**HISTORIC PRESERVATION REVIEW BOARD
STAFF REPORT AND RECOMMENDATION**

Landmark/District:	Mount Pleasant Historic District	(x) Agenda
Address:	17th Street and Oakwood Terrace, NW Square 2621, Lot 798	() Consent
Meeting Date:	December 16, 2010	(x) New construction
Case Number:	11-071	() Addition
		() Alterations
Staff Reviewer:	Tim Dennée	(x) Concept

The applicant, owner and architect Carmel Greer, requests the Board's conceptual review of a proposal to subdivide the vacant lot at the intersection of Oakwood Terrace and 17th Street and construct rowhouses.

Subdivision and site plan

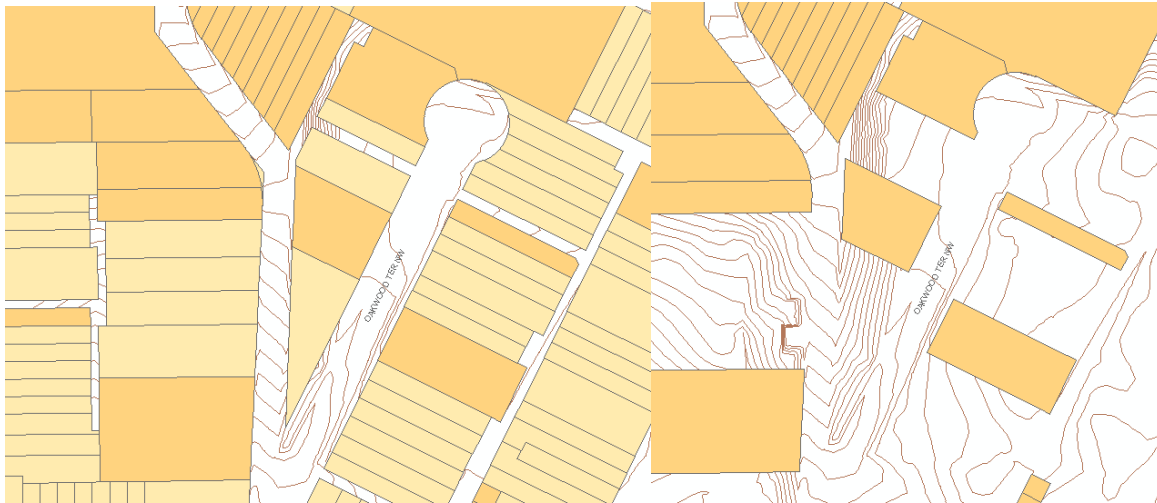
The property drops steeply to the west, toward 17th Street and the Rock Creek valley. The topography explains why this is perhaps the last unbuilt parcel in Mount Pleasant. The triangular lot would be divided into three, with the common property lines perpendicular to Oakwood Terrace. The houses would thus face Oakwood and, not as deep as the lots themselves, they would allow room for some parking on the 17th Street side and terraces or partial yards. The front yards would be very shallow, with only a few feet between sidewalk and building facades. This is necessitated by the limited depths of the lot, but also by the fact that pushing the buildings westward down the slope while maintaining the entrances at the Oakwood grade would require more extensive foundations.

The center lot would accommodate two attached units, as the R-4 zoning permits two-family "flats." The length of the southernmost house, squeezed by its narrow lot, would run perpendicular to the other houses, giving it a distinctive massing.

For reasons of retaining the site grade and enclosing the parking, there would be a very tall masonry wall on the 17th Street side of the site. The owner also proposes to construct a public sidewalk along 17th Street outside this wall. It would necessarily be quite narrow and steep.
